SUBJECT: SAN ONOFRE NUCLEAR GENERATING STATION (SONGS)
RESPONSE TO SAN DIEGO BAY COUNCIL COMMENTS

We have reviewed San Diego Bay Council's (SDBC) letter dated March 8, 2005 submitting comments on the renewal of the SONGS Units 2/3 NPDES permits. We offer the following comments in response as well as information to assist the RWQCB in its response. We have followed SDBC's comment numbering convention for convenience. Footnotes to our comments reference various supportive studies, policies, reviews and other technical documents. Although all of these references should be located in the RWQCB's files, we can provide an additional copy if desired.

Design of the SONGS Intake and Diffuser System

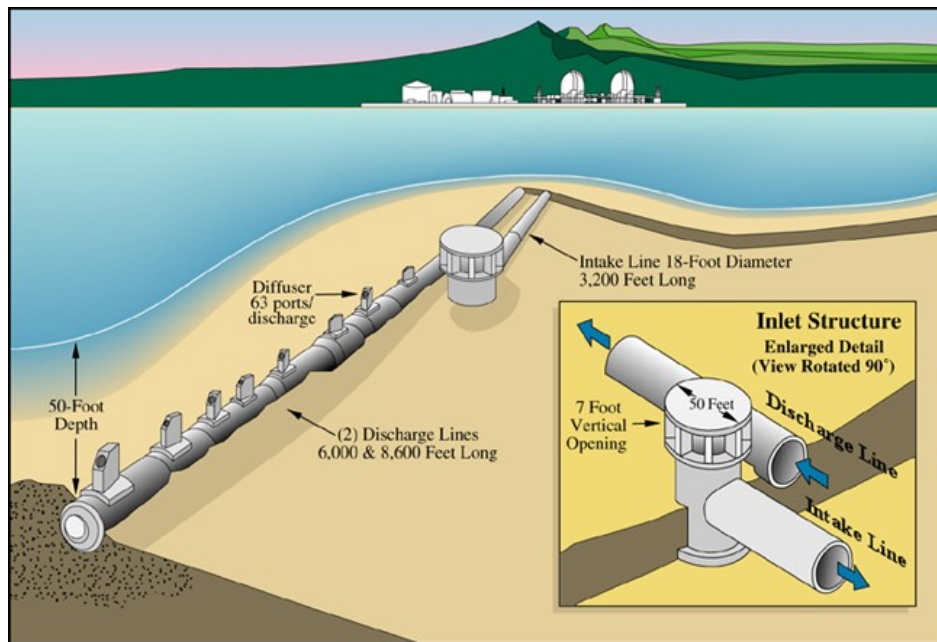
The Ocean Plan objectives for chlorine are unique, in that they account for the non-conservative nature of chlorine in ocean waters (chlorine rapidly dissipates through chemical reactions with seawater). Finally, the design and offset location of the SONGS discharge conduit diffusers ensure that the Zones of Initial Dilution (ZIDs) of each outfall do not overlap or impinge upon one another; that is, initial dilution is completed before the diffuser plumes combine. Therefore, additive effects of the discharges speculated by SBDC do not occur. This fact has been verified not only by comprehensive hydraulic modeling of the discharge plumes⁸, but by quarterly receiving water monitoring for temperature, dissolved oxygen and pH.

Thermal Plume from the SONGS Diffusers at 20oF and 25oF Effluent Temperature, No Current (Intakes are located below the bottom of each diagram)

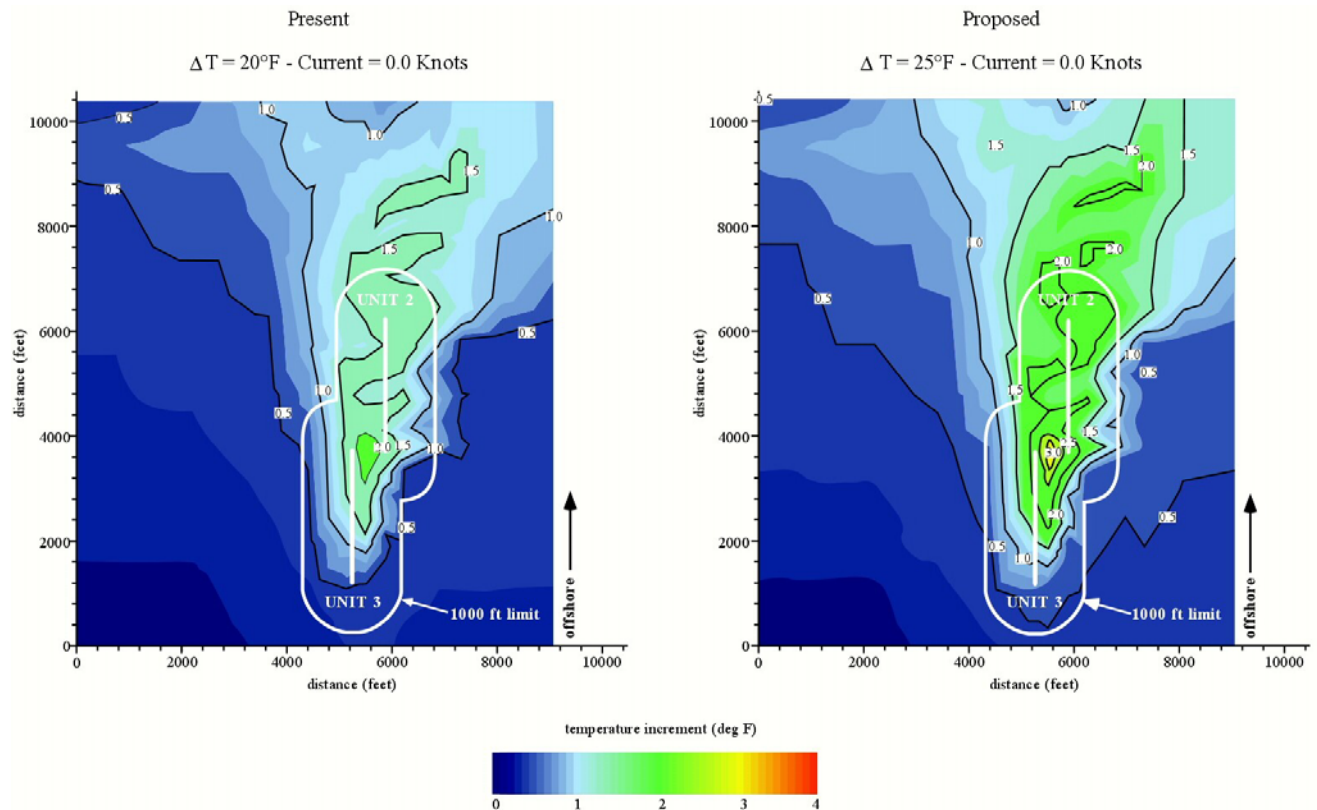
A.2. SDBC inquires as to whether intake temperature is higher than natural receiving water temperature, owing to the proximity of the offshore intakes to the discharge diffusers. The answer is simply “no”. The SONGS offshore conduits were specifically designed to prevent warmer effluent from being recirculated into the SONGS intakes in order to maximize the efficiency of the steam condensers. The design also ensures compliance with Thermal Plan receiving water limits. Integral to this design are the 2500 foot-long diffusers themselves, each incorporating 63 separate discharge ports angled upward and offshore to increase effluent discharge velocity and ensure that heated effluent actively travels away from the near shore intakes. An inspection of receiving water temperature data from any of SCE's annual receiving water monitoring reports⁹ demonstrates the effectiveness of the diffuser design. The design of the diffusers and a graphic representation of their effectiveness at discharge temperatures of 20°F and 25°F are shown in the following diagrams, from the FlowScience report referenced in Footnote No. 8.

SDBC asserts that "there is a relatively short distance between the intake and the nearest effluent discharge location." Both intakes are located 3,183 feet offshore, while the nearest discharge port of the 2,500 foot-long Unit 3 diffuser is located 3,388 feet offshore, or 205 feet from the intakes. This distance between the intakes and the diffuser lines is irrelevant, because the effluent velocity caused by the diffuser ports induces a current in the offshore direction, carrying effluent away from the intakes and shoreline by design, as shown in the preceding figures. This distance information is clearly provided on Page E-4 of the Tentative Orders.
